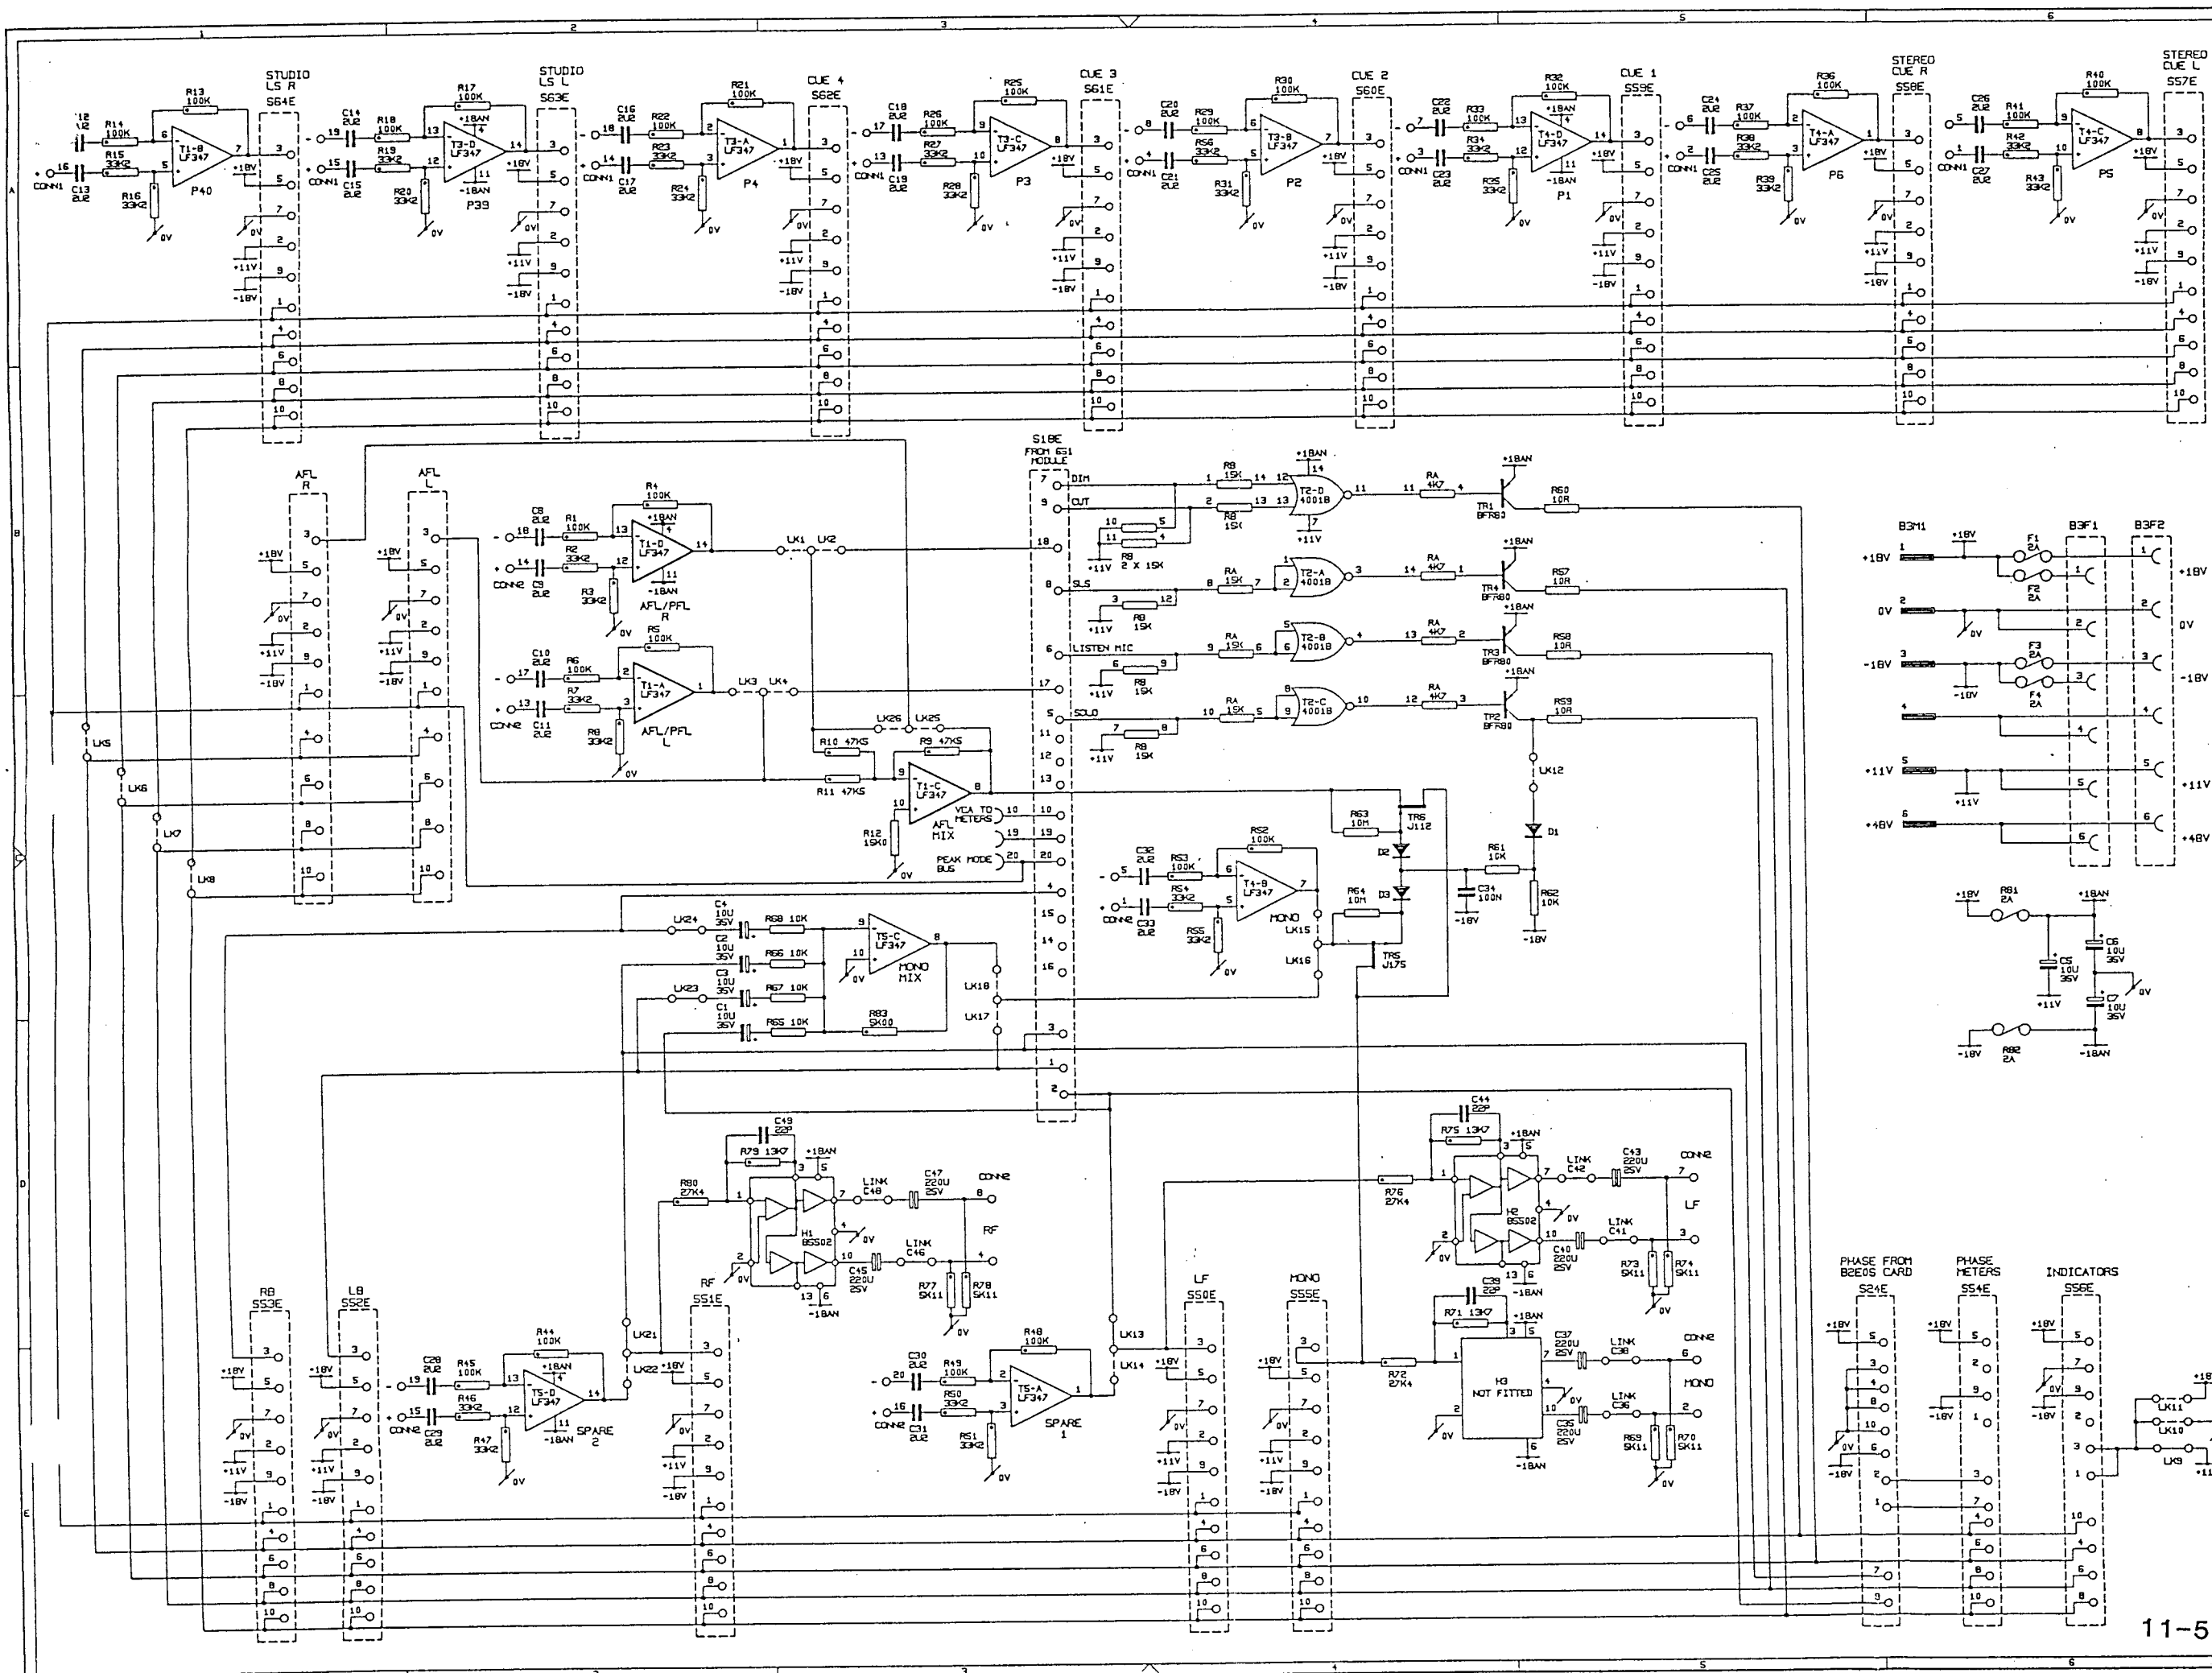
REVISIONS			DETAILS
0	A	MAR 86	ECO 4K/161 REPLACES BRESS CARD
1	A	29 JAN 80	ECO 4K/184 TR1-4 EXITTERS CONN TO FILTERED POWER SUPPLY
2	A	29 JAN 80	ECO 4K/236 O/P HYBRIDS WERE 265502A1 NOW 265502A2 R72/76/80 WERE 15K NOW 17K2 R71/75/79 WERE 15K NOW 13K7 CAP PAIRS C35/36 C37/38 40/41 42/43 C15/16 47/48 WERE 2 X 220U NOW 1 X 220U
3	A	29 JAN 80	ECO 4K/268 R69,70/73/74/78 WERE TO -18V NOW TO 0V, DE POLARITY REVERSED ON SILK SCREEN
4	A	13 FEB 80	ECO 4K/516 R63 WAS 8K8 NOW 5K0
5	A	12 SEPT 80	ECO 4K/603 B.O.M. AMENDED TO INCORPORATE JK REV PCB
6	A	31 MAR 82	ECO 4K/910 R61 R62 WERE 10K NOW 2A FUSE. RA HWS 15K RESISTOR PACK NOW DISCRETE 4K7 & 15K. LINKS LK23-24 NOW FITTED
7	A	7 MAY 82	ECO 4K/952 R61 WAS 100K NOW 10K R72 R76 R80 WERE 17K2 NOW 27K4
7	B	13 APR 83	CIRCUIT CORRECTION LINKS TO LINKS WERE TWO POSITION LINKS NOW ONE POSITION
8	A	5 MAY 83	ECO 4K/1131 H1 H2 WERE NOT FITTED NOW FITTED
